GLASFLÜGEL
ING. E. HÄNLE
7311 SCHLATTSTALL

TECHNISCHE MITTEILUNG TECHNICAL NOTE

Nr: 301-28 e

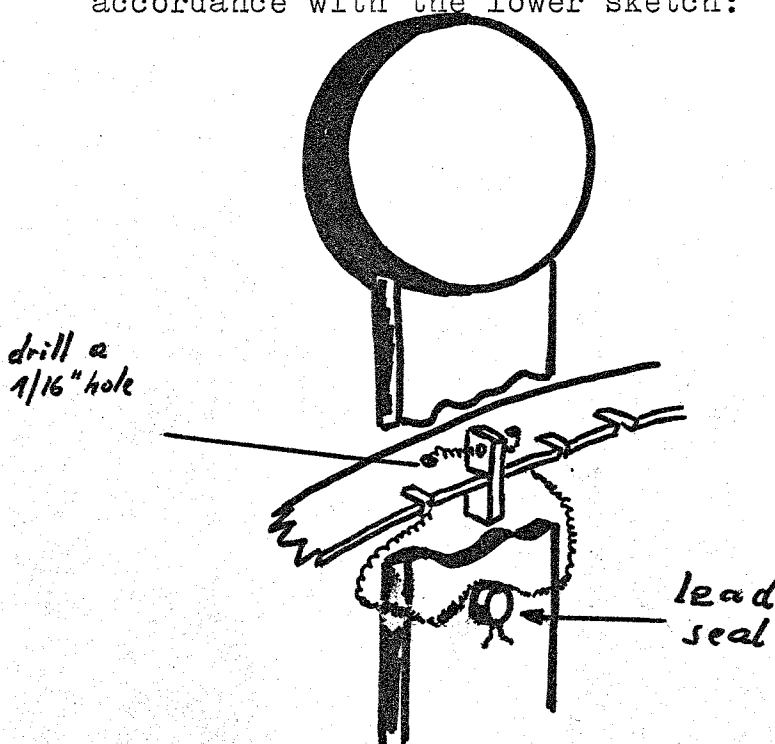
- UNITS AFFECTED : All gliders model "H301 & H301B Libelle"
German Data Sheet No.251, U.S.ATC No.G12EU.
- SUBJECT : Flap mechanism seal for Standard Class Contests.
- REASON : For a participation of gliders model "H301 or
H301B Libelle" in U.S.Standard Class Contests
it was suggested to seal the flap lever in
order to prevent operation of flaps .
- PROCEDURE : 1.)The pilot may determine what the flap
setting throughout the contest is to be,
however, only the flap lever setting 0,
+1 or +2 is permitted to be sealed in
accordance with the lower sketch:

2.)In case, that a change of the flap setting is necessary, the break forces on the flap lever should not exceed 8 kp, therefore the correct seal wire must be used.

3.)The following cockpit placard must be installed in view of the pilot:

OPERATION OF THIS GLIDER IN U.S.STANDARD CLASS CONTESTS IS PERMITTED IF FLAP LEVER IS SEALED. SEAL WILL BREAK IF LEVER IS USED. DO NOT EXCEED MAX.PERMITTED SPEED SHOWN ON FLAP INDICATOR PLATE.
